Project	IEEE 802.16 Broadband Wireless Access Working Group < http://ieee802.org/16 >	
Title	H-ARQ support corrections, for OFDMA PHY mode	
Date Submitted	2004-04-15	
Source(s)	<p>Panyuh Joo, Seungjoo Maeng, Jaeho Jeon, panyuh@samsung.com Soonyoung Yoon, Jeong-Heon Kim, Jaehyok Lee, Myungkwang Byun, Inseok Hwang, yigall@runcom.co.il Jaehee Cho, Jiho Jang, Sanghoon Sung, Samsung Electronics Co. Ltd. lim@etri.re.kr</p> <p>Yigal Leiba, Zion Hadad, Yossi Segal, Itzik Kitroser Runcom Technologies</p> <p>Choongil Yeh, Hyuongsso Lim, Yuro Lee, Jongee Oh, DongSeung Kwon, ETRI</p>	
Re:	Sponsor re-circulation Ballot	
Abstract	H-ARQ support corrections, for OFDMA PHY mode	
Purpose	Adoption of proposed changes into P802.16-REVd/D4-2004	
Notice	This document has been prepared to assist IEEE 802.16. It is offered as a basis for discussion and is not binding on the contributing individual(s) or organization(s). The material in this document is subject to change in form and content after further study. The contributor(s) reserve(s) the right to add, amend or withdraw material contained herein.

In page 529, line 47, correct section 8.4.9.2.3.1 as shown below:

Figure 240—CTC encoder

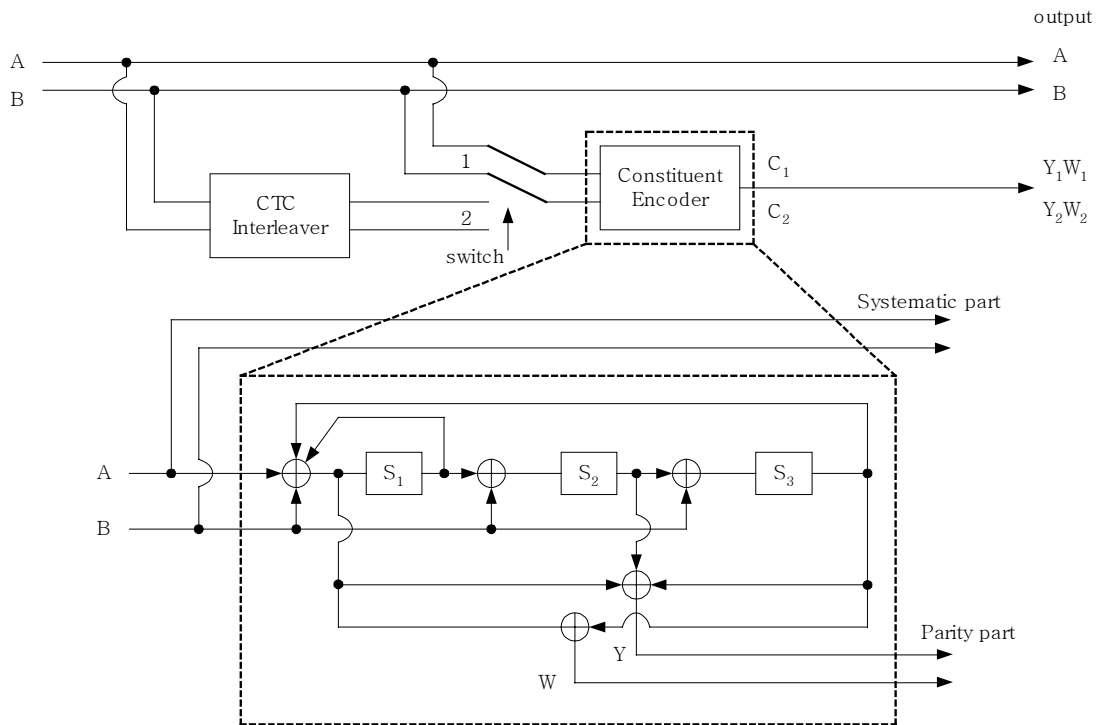
First, the encoder (after initialization by the circulation state S_{c1} , see 8.4.9.2.3.3) is fed the sequence in the natural order (position 1) with the incremental address $i = 0 .. N-1$. This first encoding is called S_{c1} encoding. Then the encoder (after initialization by the circulation state S_{c2} , see 8.4.9.2.3.3) is fed by the interleaved sequence (switch in position 2) with incremental address $j = 0, \dots, N-1$. This second encoding is called C_2 encoding.

The order in which the encoded bit shall be fed into the [interleaver \(8.4.9.3\)](#) [data modulation block \(8.4.9.4.2\)](#) is:

$$\underline{A, B, Y_1, W_1, Y_2, W_2 = A_1, A_2, \dots, A_N, B_1, B_2, \dots, B_N, Y_{11}, Y_{12}, \dots, Y_{1N}, W_{11}, W_{12}, \dots, W_{1N}, Y_{21}, Y_{22}, \dots, Y_{2N}, W_{21}, W_{22}, \dots, W_{2N}}$$

$$\underline{A, B, Y_1, Y_2, W_1, W_2 = A_1, B_1, \dots, A_N, B_N, Y_{11}, Y_{12}, \dots, Y_{1N}, Y_{21}, Y_{22}, \dots, Y_{2N}, W_{11}, W_{12}, \dots, W_{1N}, W_{1N}, W_{21}, W_{22}, \dots, W_{2N}}$$

[Note that this interleaver \(8.4.9.3\) shall not be used when using CTC](#)

Figure 245—Block diagram of the interleaving scheme

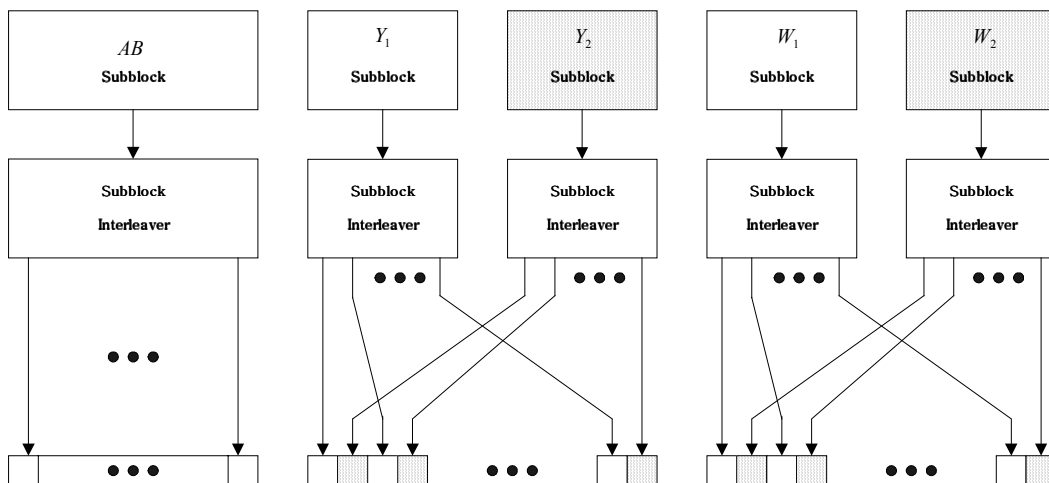
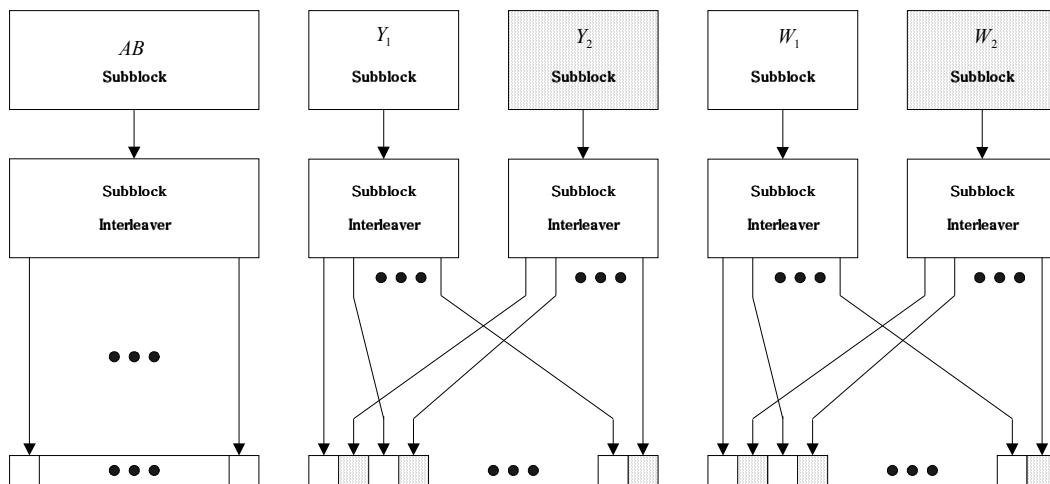
Figure eee245 shows block diagram of the interleaving scheme of the proposed FEC structure. At first, the CTC encoder output is separated into a subblock. Then the interleaving is applied for the bit sequence within the subblock. It guarantees the uniformity of the interleaved codeword. Next, Symbol grouping is performed such that the parity bits from the two constituent encoders are interleaved bit by bit. The systematic part of the 1/2 CTC encoder is located at the head of the interleaved codeword. In this way, the proposed FEC structure ensures the quasi-complementary characteristics of the interleaved codeword and thus, complementary characteristics of the subpacket. We just say “quasi-complementary” for the case of breaking the complementariness of few bits after puncturing.

Figure eee – PRBS of the randomizer

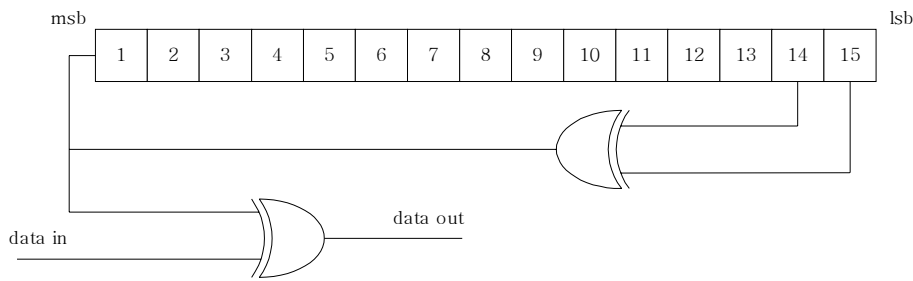
The Pseudo Random Binary Sequence (PRBS) generator shall be $1 + X^{14} + X^{15}$ as shown in Figure eee. Each data byte to be transmitted shall enter sequentially into the randomizer, MSB first. The seed value shall be used to calculate the randomization bits, which are combined in an XOR operation with the serialized bit stream of each burst. The randomizer sequence is applied to the output from the padding block. The bit issued from the randomizer shall be applied to the CRC encoder.

Figure fff – Initialization construction for the PRBS of the randomizer

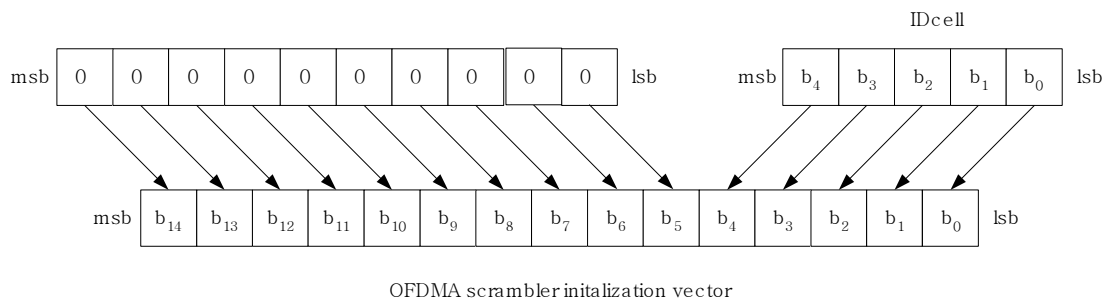
The scrambler is initialized with the vector created as shown in Figure fff. The lowest 5 bits are ID_{cell} or UL_ID_{cell} and the other bits are set '0'.

Figure 125—Construction of H-ARQ encoder packet

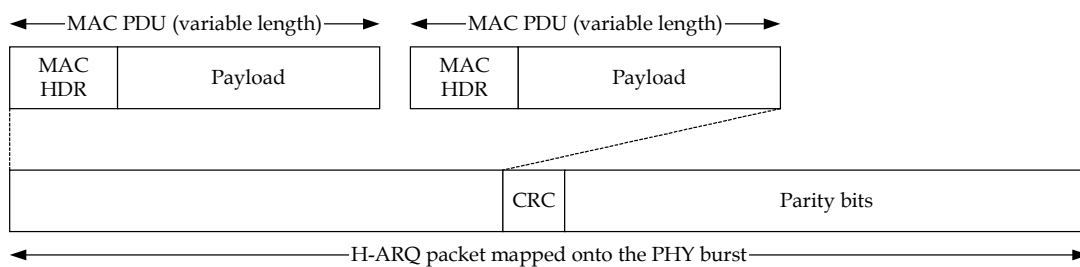
One or more MAC PDUs can be concatenated and an H-ARQ packet formed by adding a CRC to the PHY burst. Figure 125 shows how the H-ARQ encoder packet is constructed.
